**TO:** Planning and Zoning Commission  
**FROM:** Brand Cooper, Zoning Administrator  
**DATE:** April 27, 2021  
**RE:** Amendment to a Conditional Use Permit and approval of a Minor Site plan for an expansion to a place of worship located at 105 Paradise Circle – Lord of Love Church

**PLANNING AND ZONING COMMISSION RESOLUTION 2021- 905**

# LORD OF LOVE CHURCH ADDITION

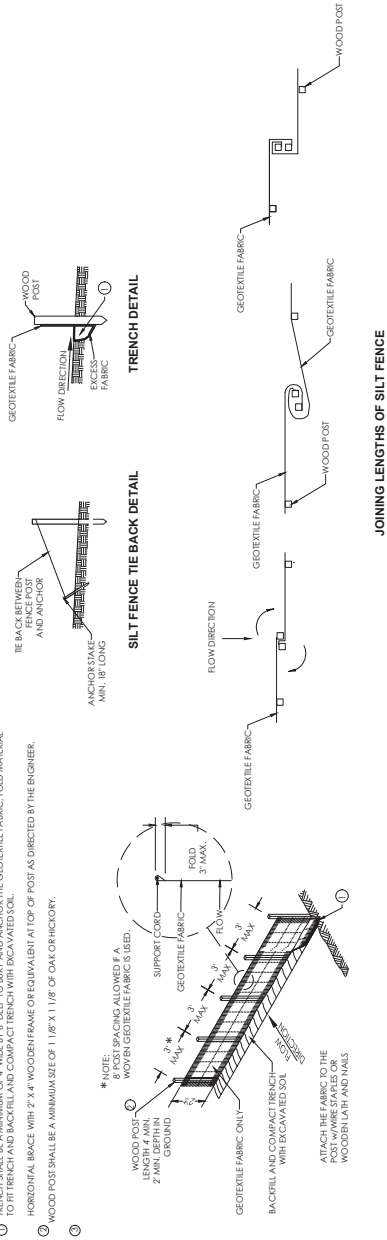
Adequate ingress and egress to minimize traffic congestion and problems	Met, with comment	Existing site has adequate driveway and aisles for vehicle stacking. I recommend some minor improvements for pedestrian safety, see site plan comments below. Overall the plan provides for adequate access to, from, and within the site.
Adequate utilities, access roads, drainage and other site improvements	Met, with comment	No new utilities needed, to staff's knowledge. If water usage exceeds the capacity of the existing services, church will be responsible for any up-sizing needed, in accordance with Village ordinances. Access seems adequate for site as proposed, see comments on parking lot design elsewhere.

- a. On a revised site plan sheet, locations and dimensions of ADA ramps to new sidewalk, wheel stops at the ends of all parking stalls abutting the existing non-elevated walkway, and location of any additional pole mounted parking lot fixtures.

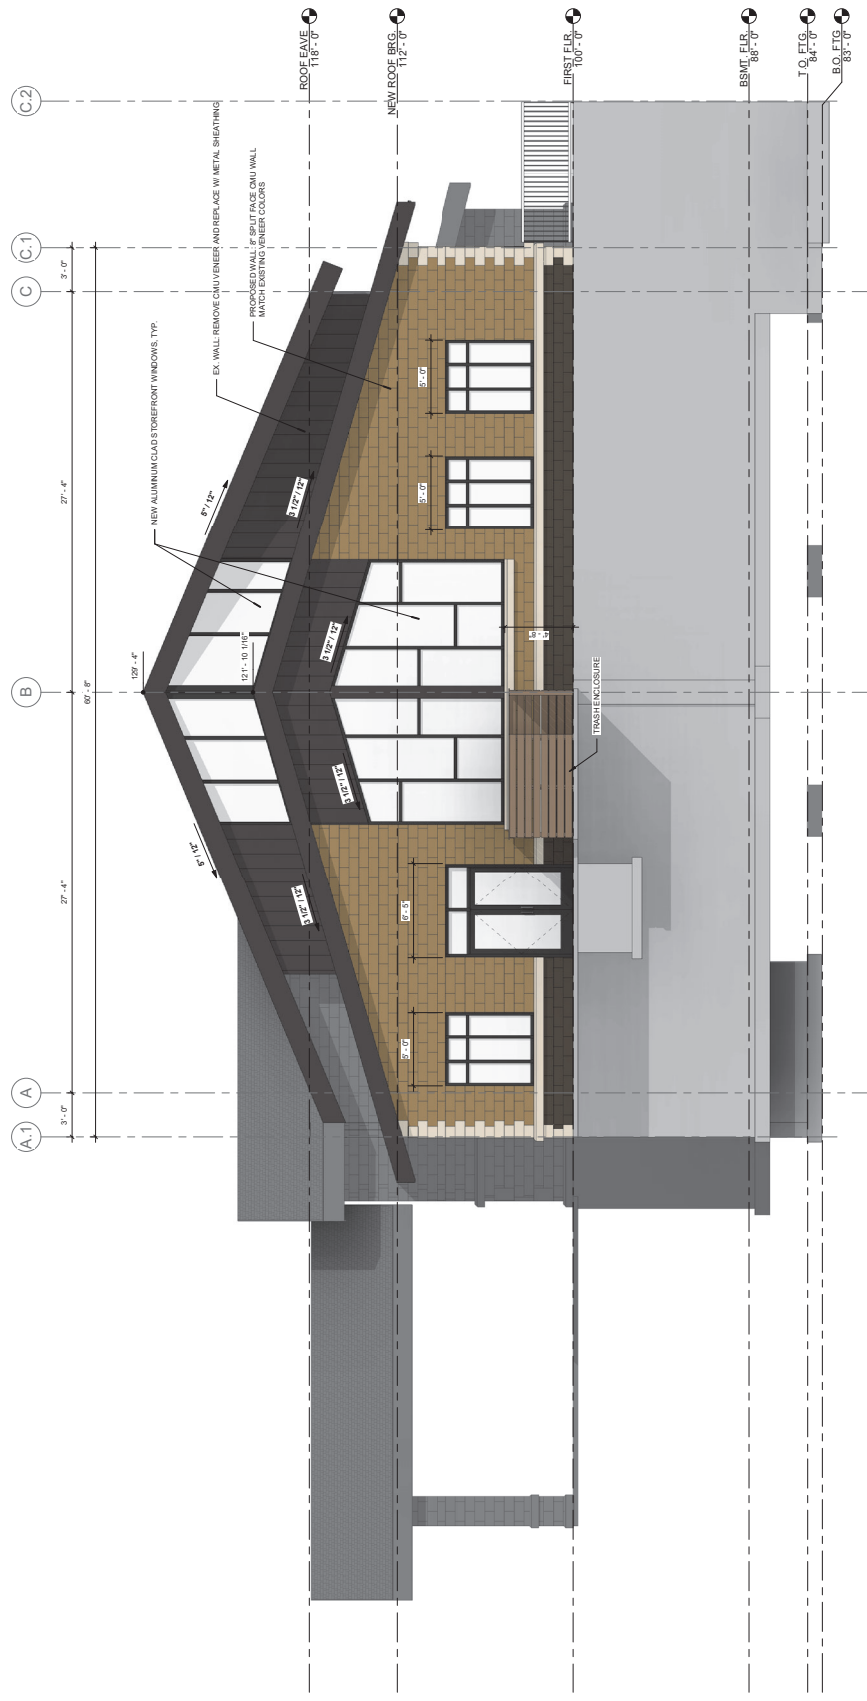
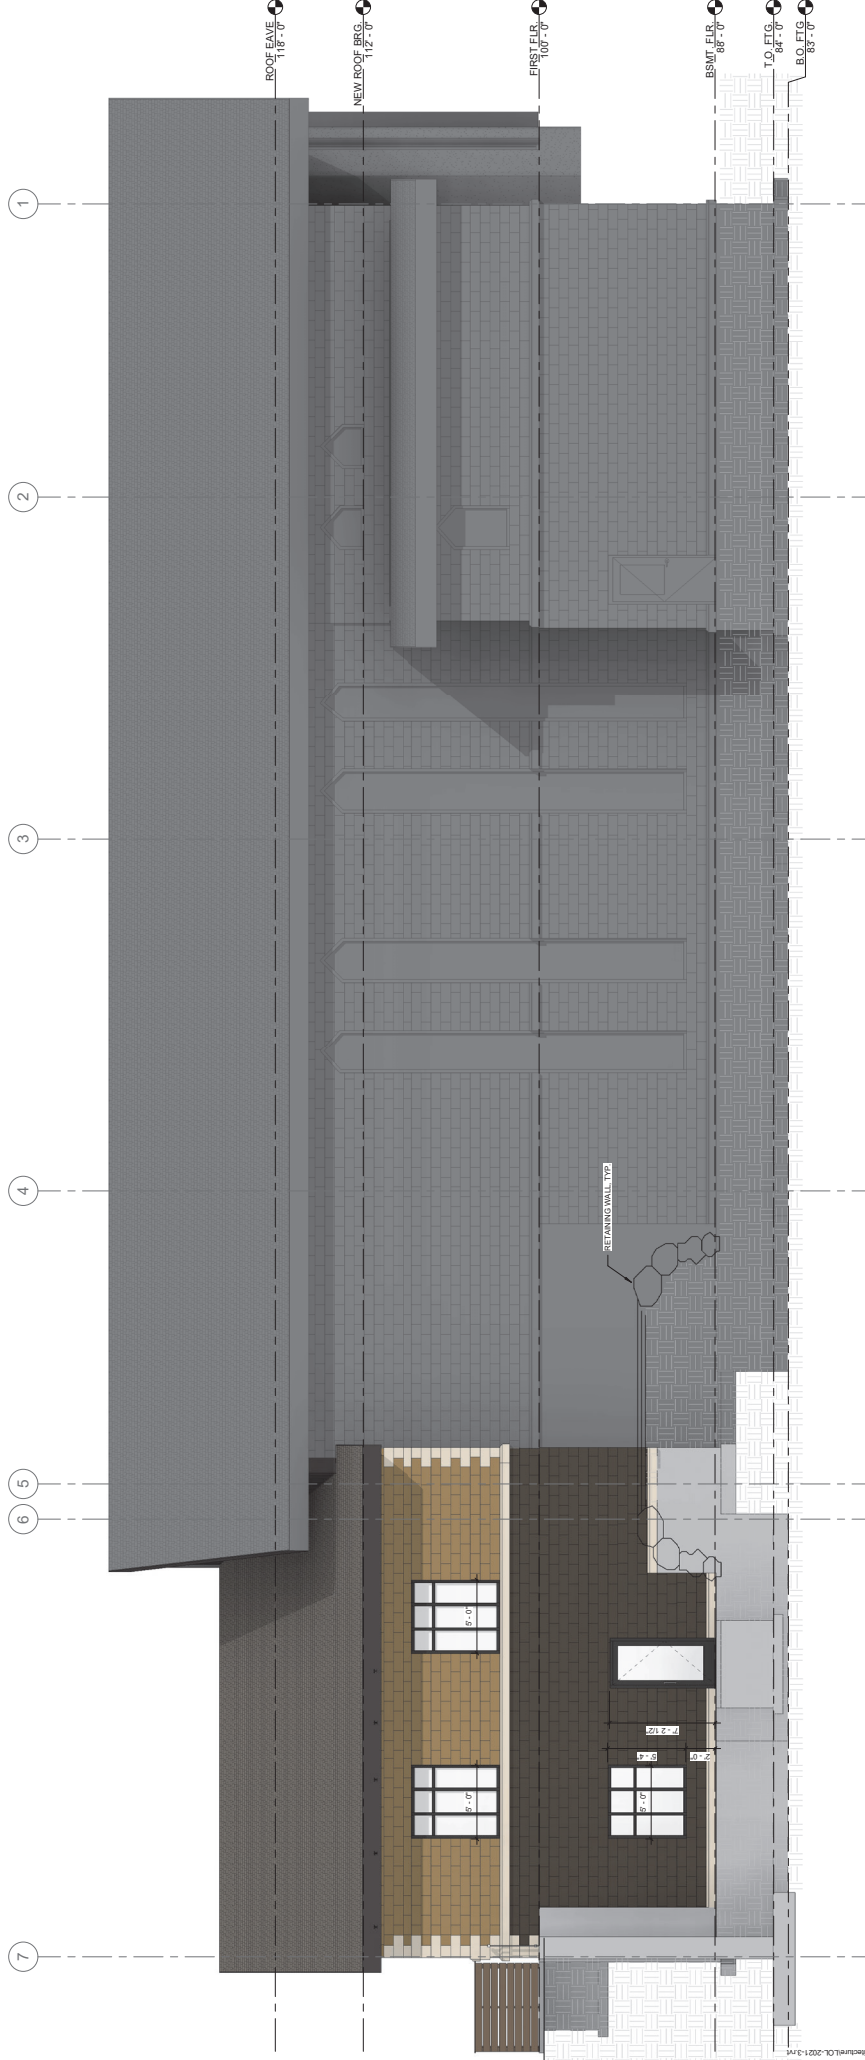
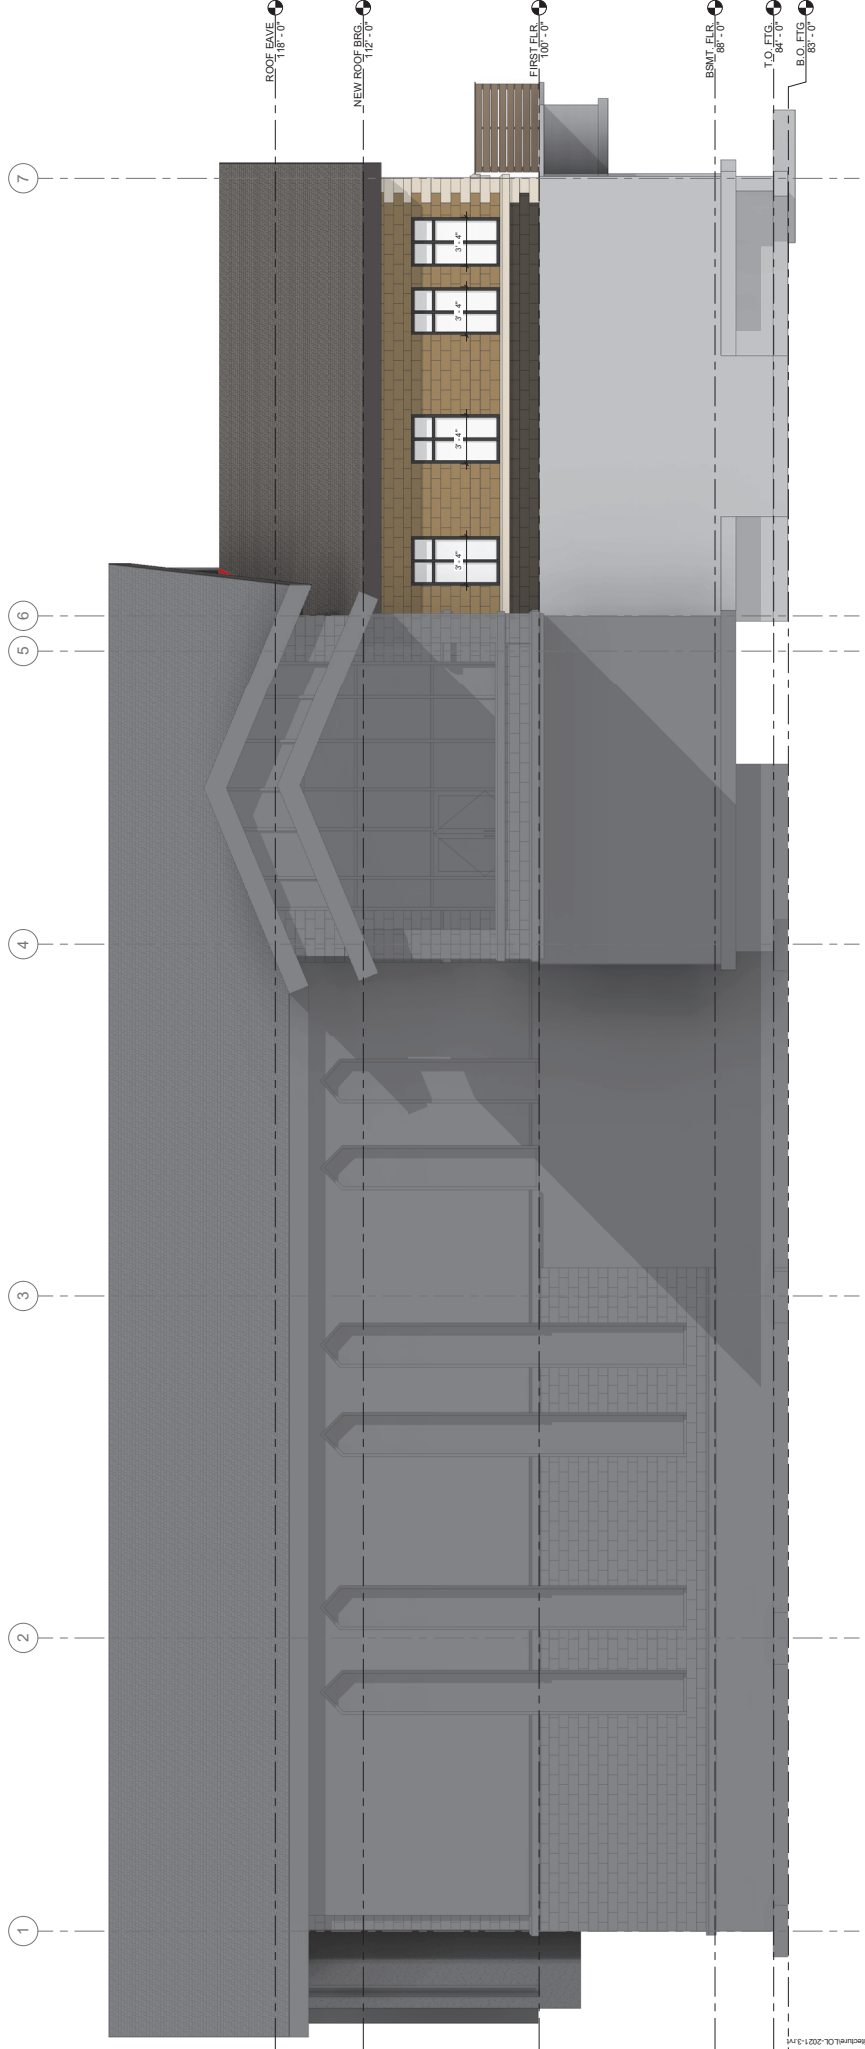
- b. On revised building elevation sheets, proposed locations of all building mounted lighting and mechanical units.
  - c. Catalog pages for new exterior lighting, meeting applicable zoning ordinance requirements as to shielding, intensity, and fixture height.
